BID NO. 2024-25.10
WILSON HIGH SCHOOL: MEDIA CENTER UPGRADE
February 11, 2025
ADDENDUM NO.01

ADDENDUM 01 Details

**WILSON HIGH SCHOOL
MEDIA CENTER REMODEL
HACIENDA LA PUENTE UNIFIED SCHOOL DISTRICT**

tBP Project No. 21211.00

MOTORIZED PROJECTION SCREEN

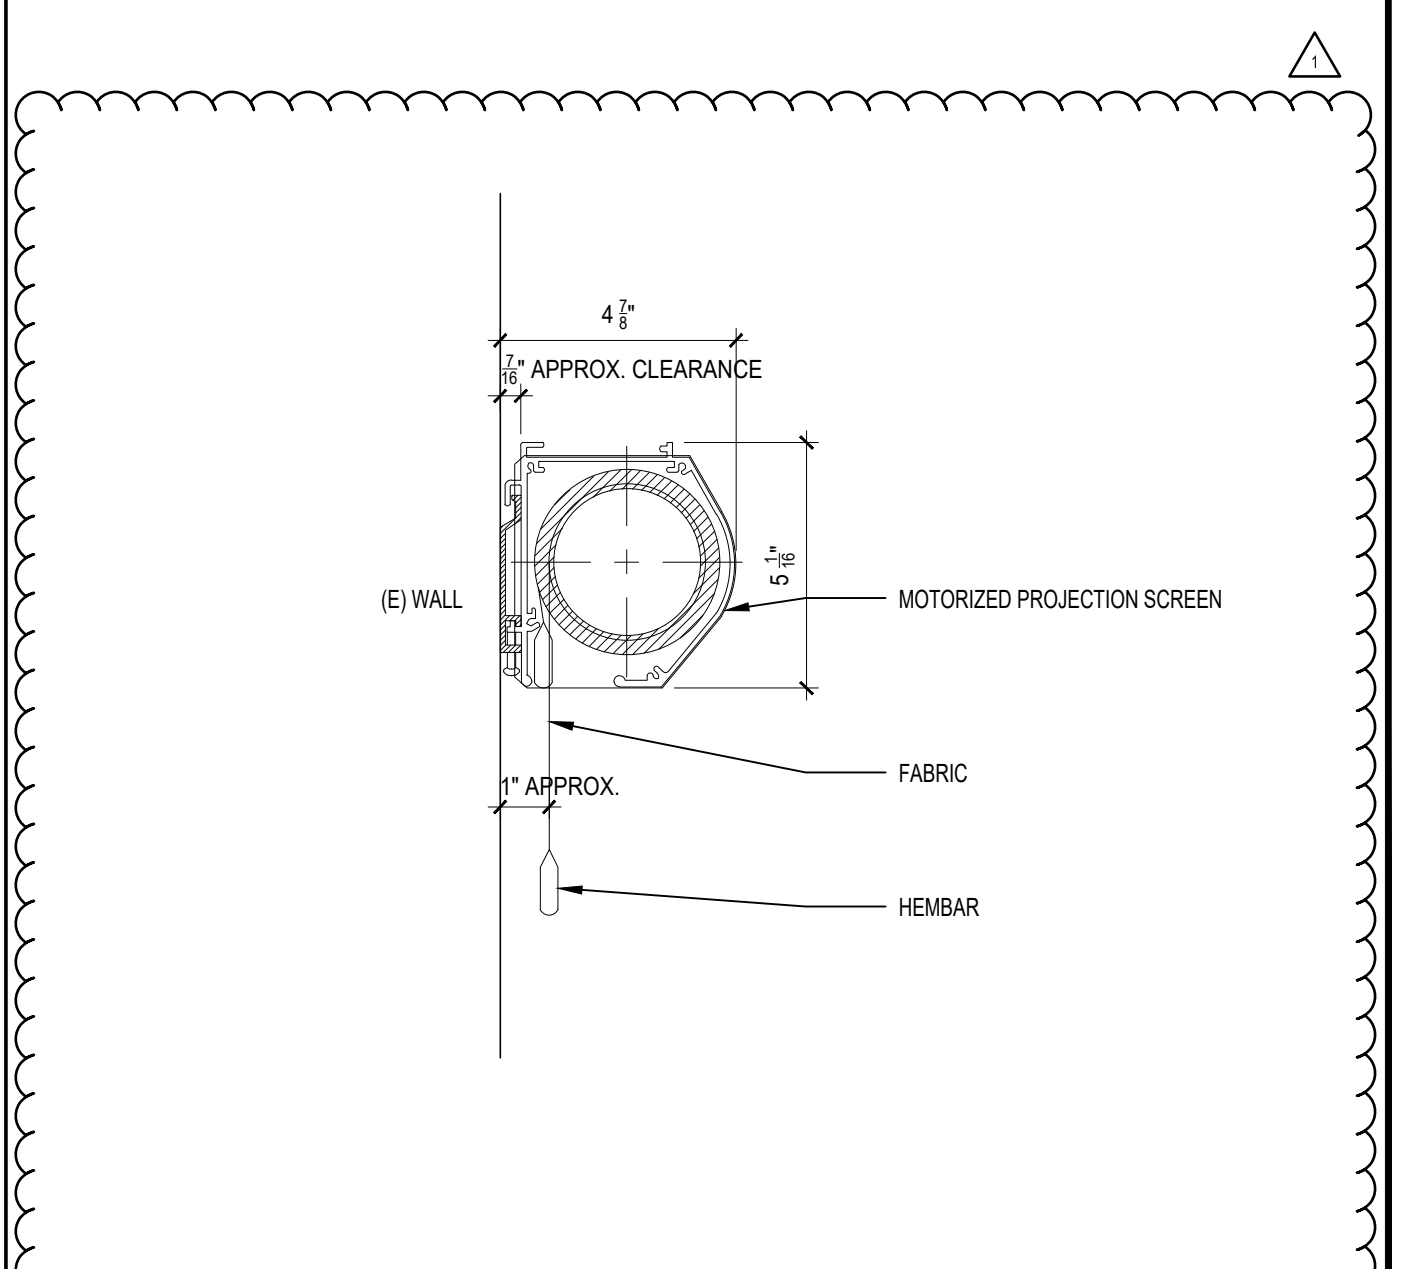
Please clarify the mounting details for the projection screens. Keynote #10 on sheet A-7 says to use 8/A-9 however that detail is for a motorized window shade. Please clarify and provide an updated detail.

Response – New projection screen mounting detail 20/A9 is provided for mounting of the screen. Plan A-7 and A-9 are attached to this addendum.

A-13

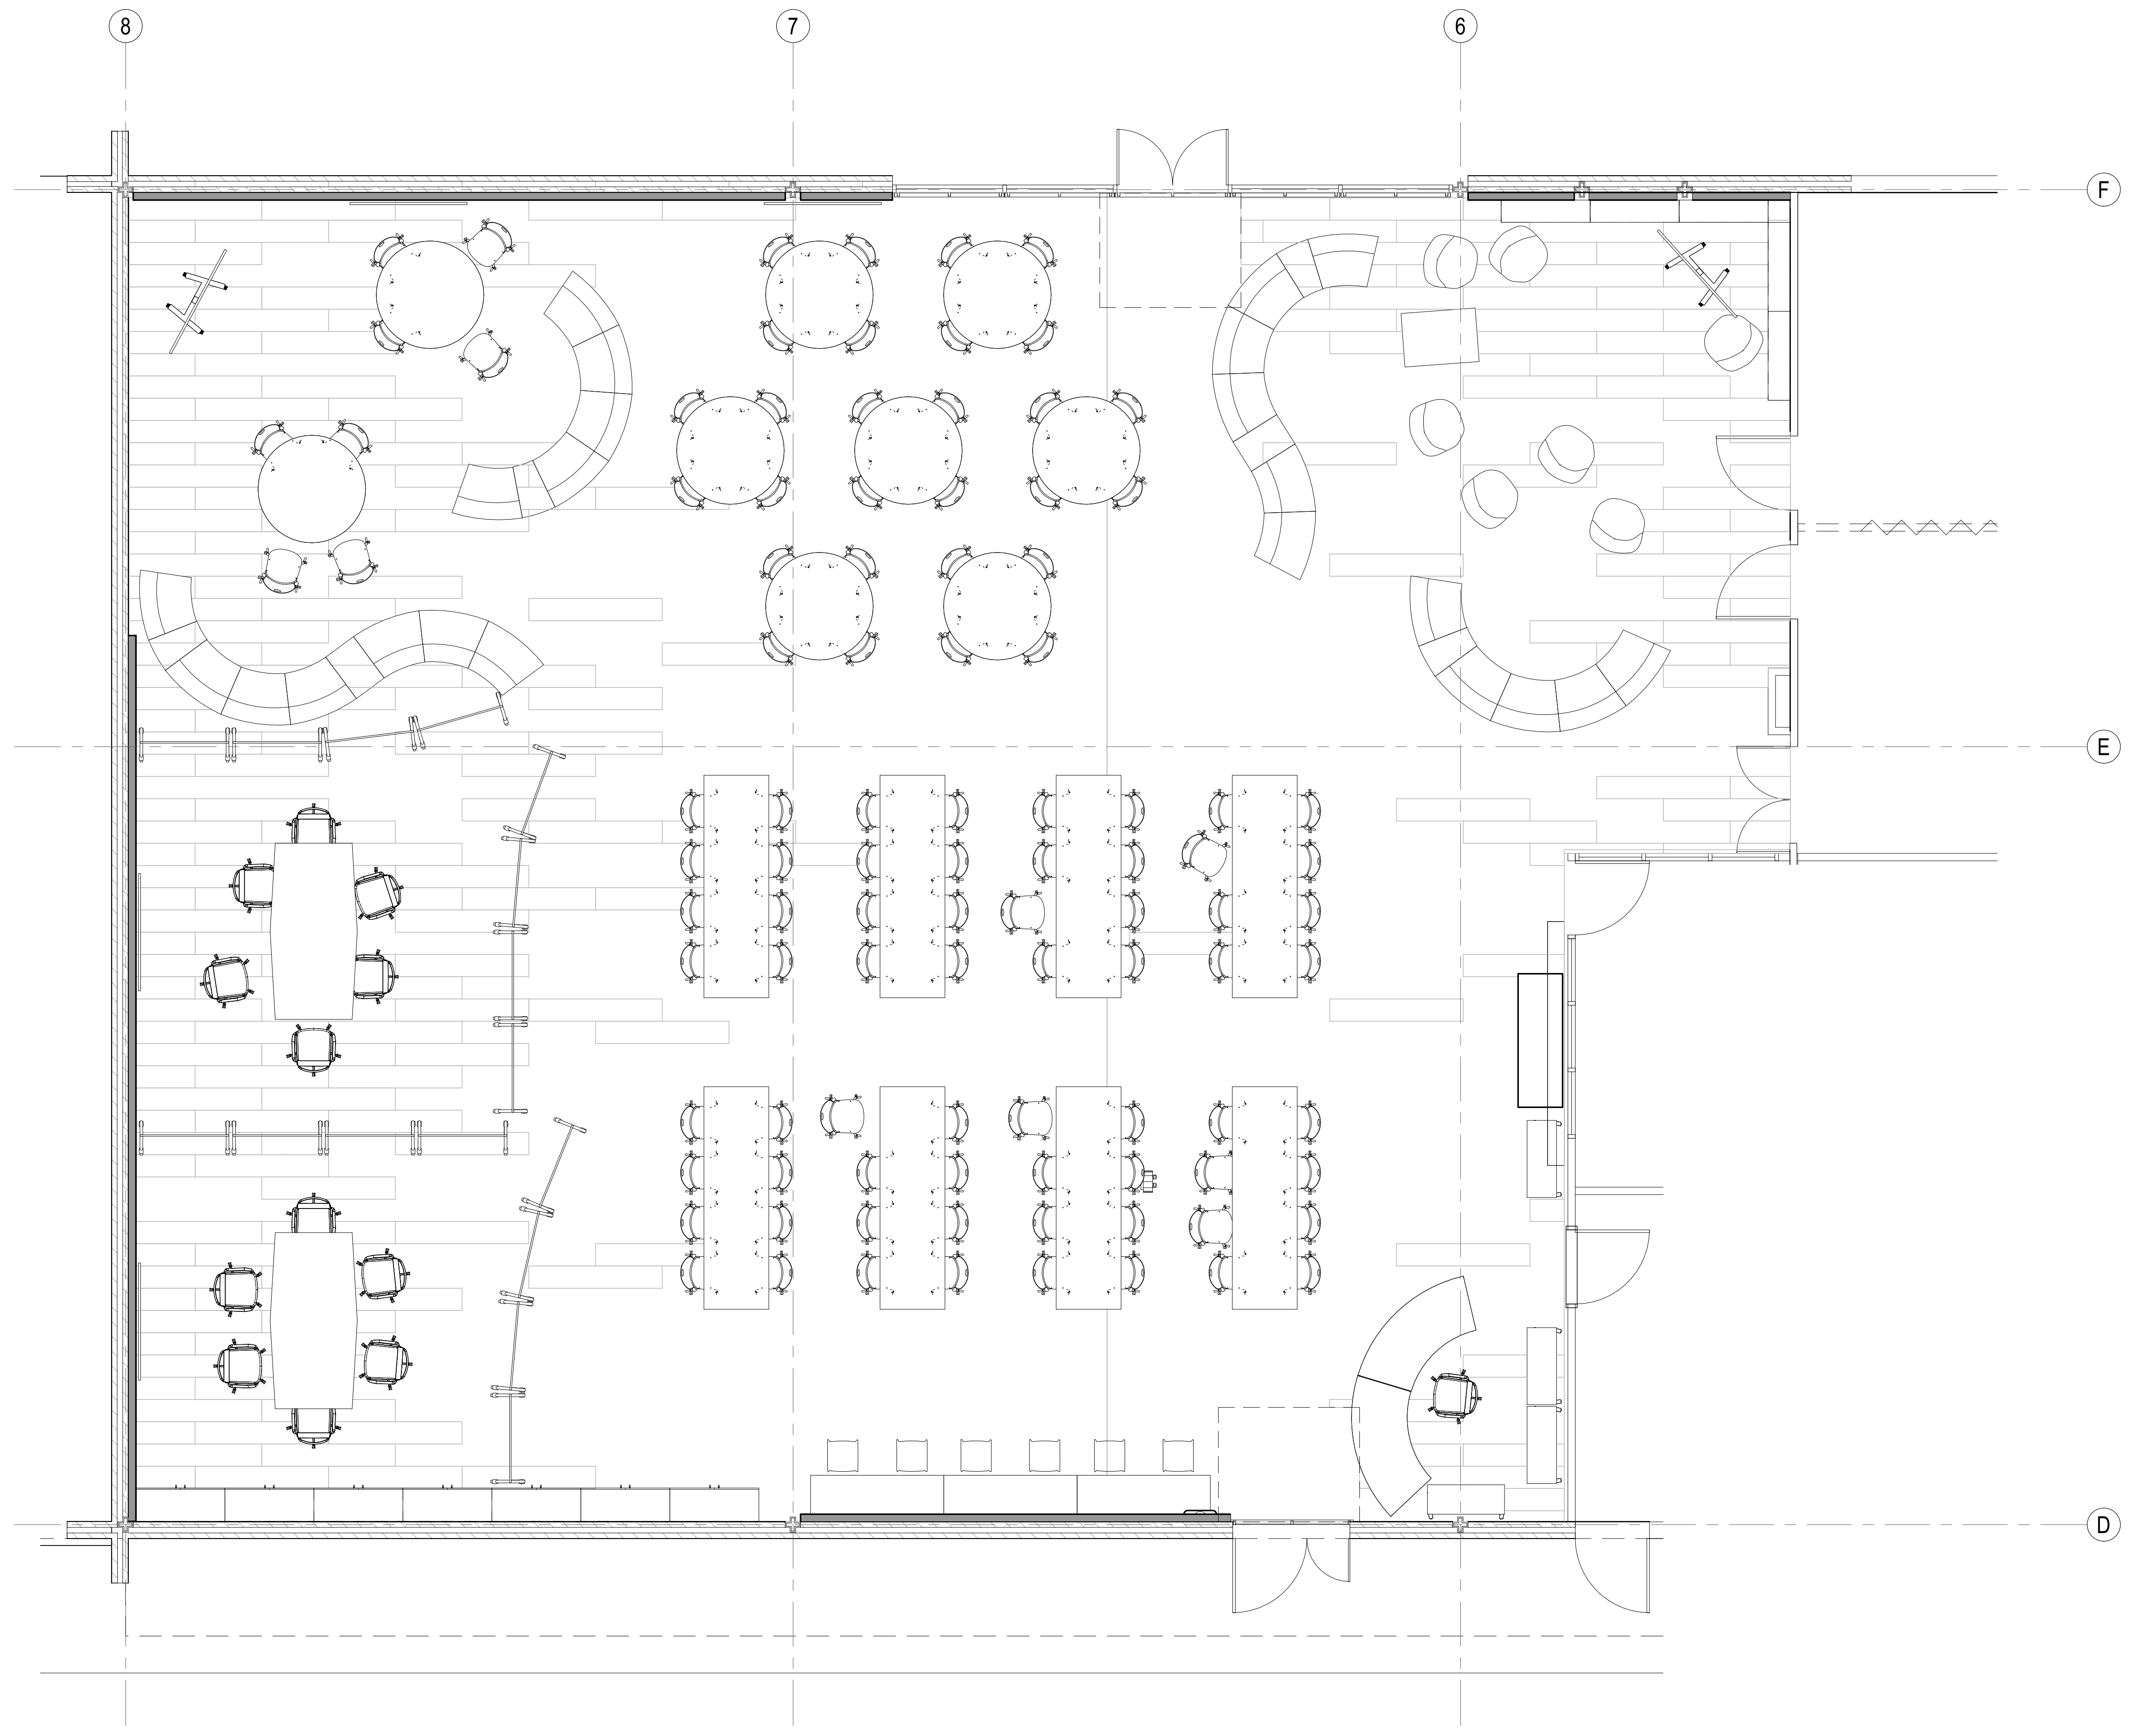
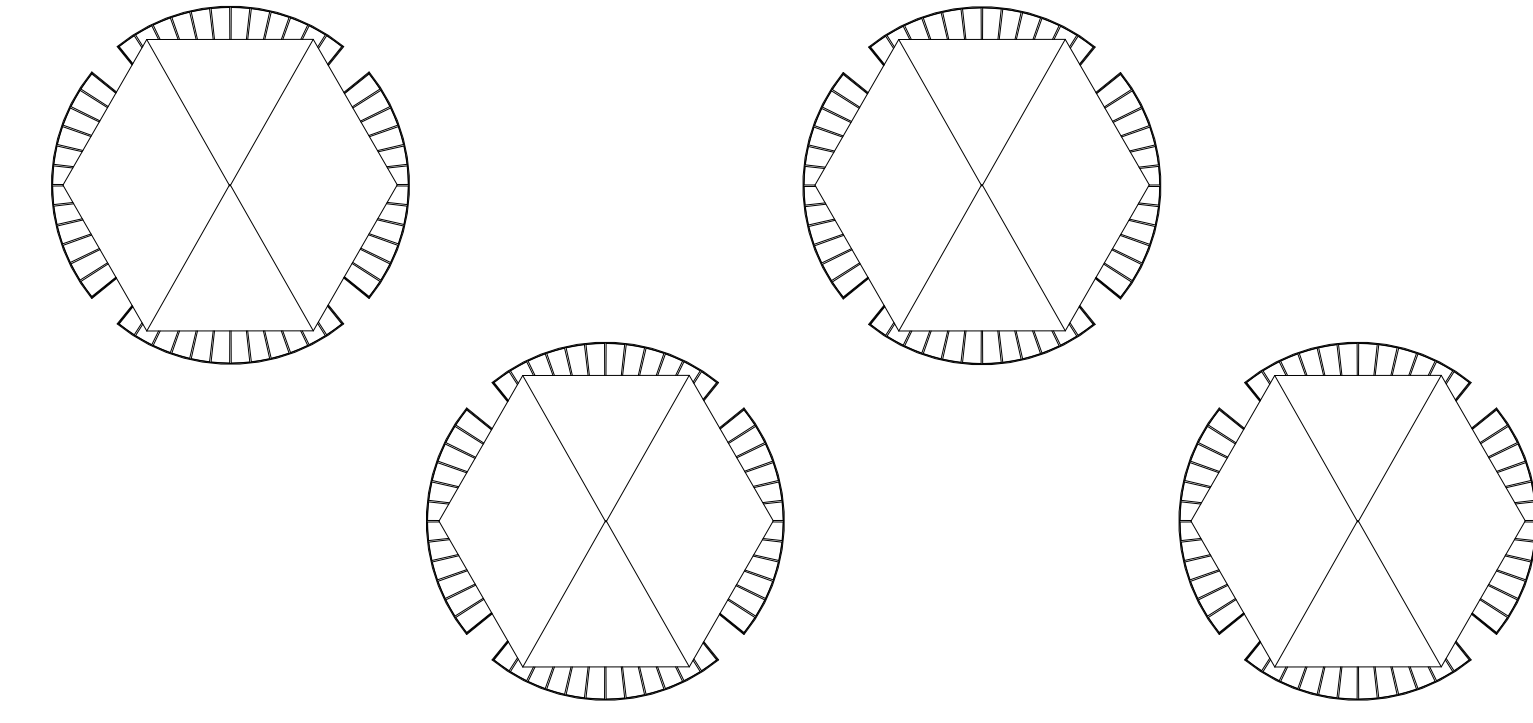
4. SHEET A-13 FURNITURE SCHEDULE
 - a. Added a note: "ALL FURNISHINGS ARE TO BE OWNER FURNISHED AND CONTRACTOR INSTALLED."
 - b. Replace Sheet A-13 Furniture Schedule sheet in its entirety issued with this addendum.

1. Sheet A-13
The furniture schedule on Sheet A-13 is for reference only. Please confirm all interior and exterior furnishings are not part of this project.

Response – The district will have the furnishings indicated on sheet A-13 to be “Owner Furnished and Contractor Installed.” Plan is attached to this addendum.

drawing title:
REMODEL POWER PLAN
drawing no.:
E-2.0
drawing of

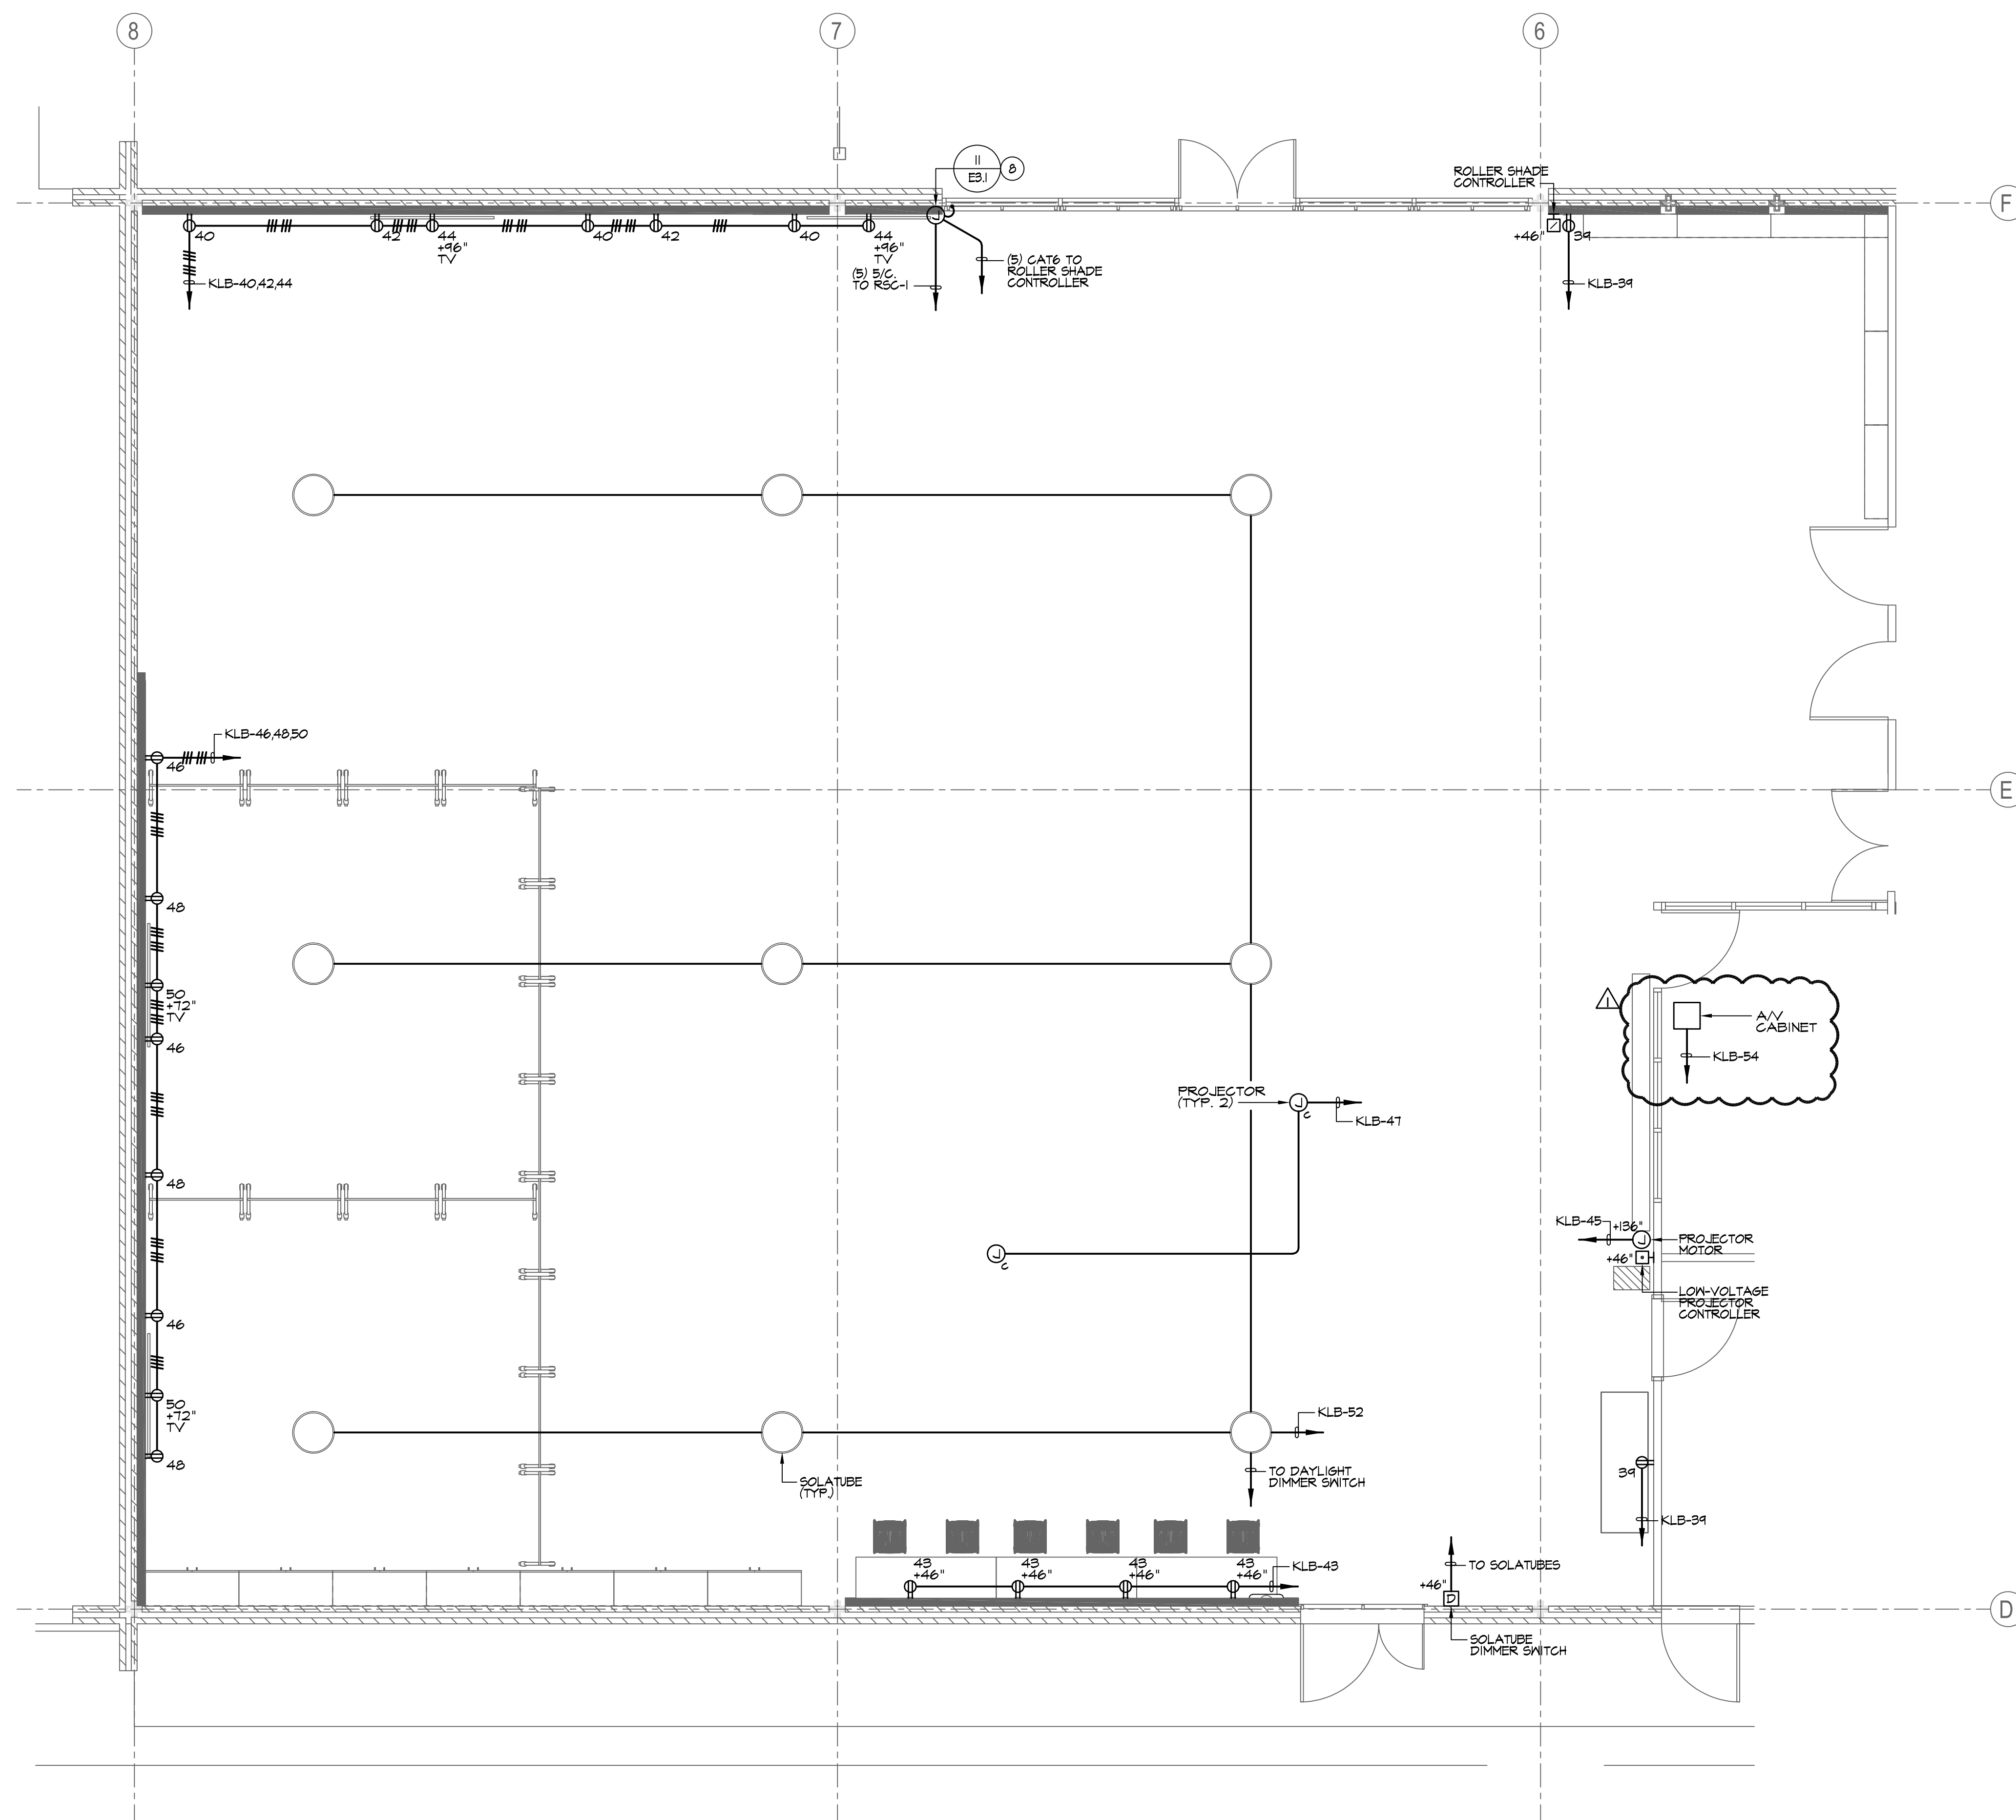
6. SHEET E2.0 REMODEL POWER PLAN
 - a. Added location of new AV Cabinet and power to Panel KLB.
 - b. Replace Sheet E-2.0 Remodel Power Plan in its entirety issued with this addendum.
